PLANS FOR THE CONSTRUCTION OF
 PAVING, BRIDGE, STORM SEWER, WATER, SANITARY SEWER
 SIGNALIZATION AND STREETScape IMPROVEMENTS FOR

ARAPAHO ROAD - PHASE III

FROM SURVEYOR BOULEVARD TO ADDISON ROAD

PROJECT RECORD COPY I

Design	Drawn	DATE	SCALE	PROJECT NO.	SHEET NO.
DAB	DAB	6/3/04	VARIES	25768	DT-08

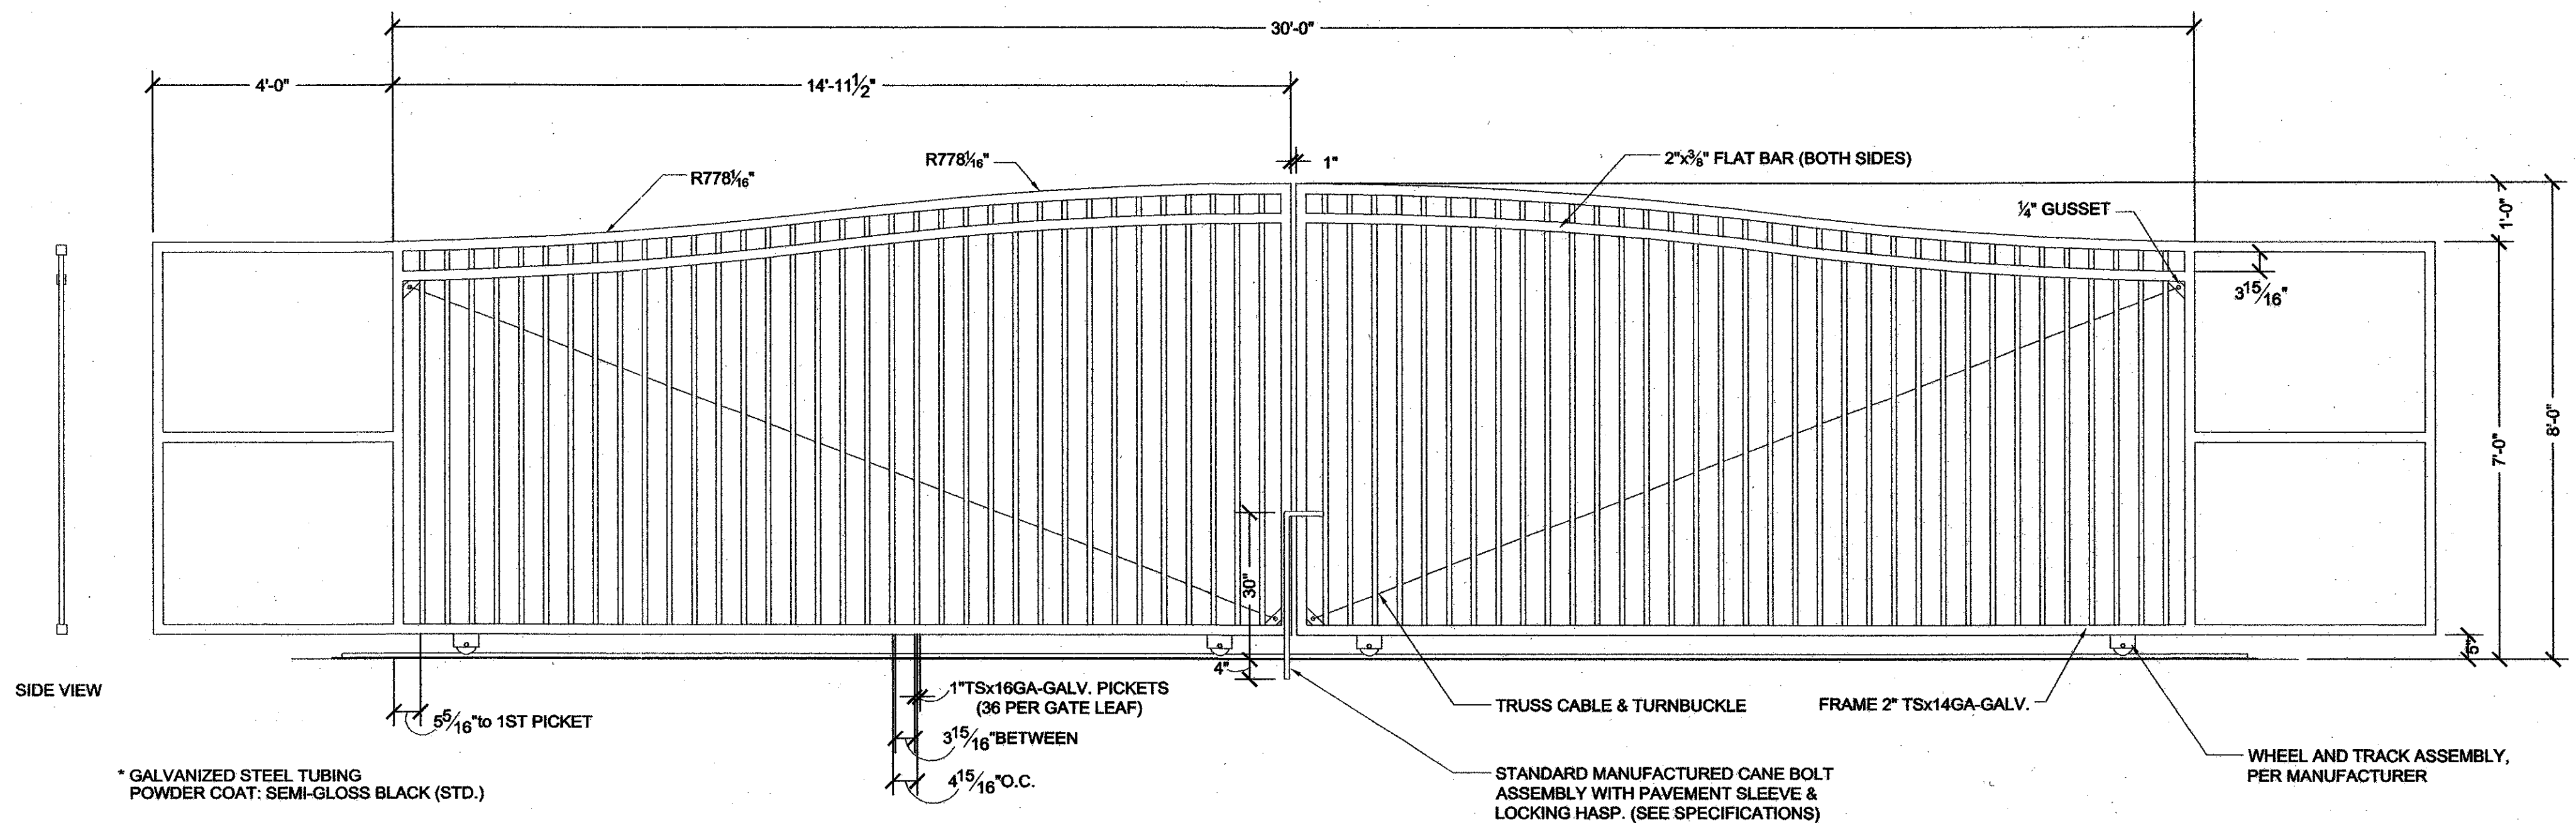
See RFI #130
Reduce width of 200' wide Level Pad to 150' in order to align Pad and Blocks with North Side of Inlet A-5B.
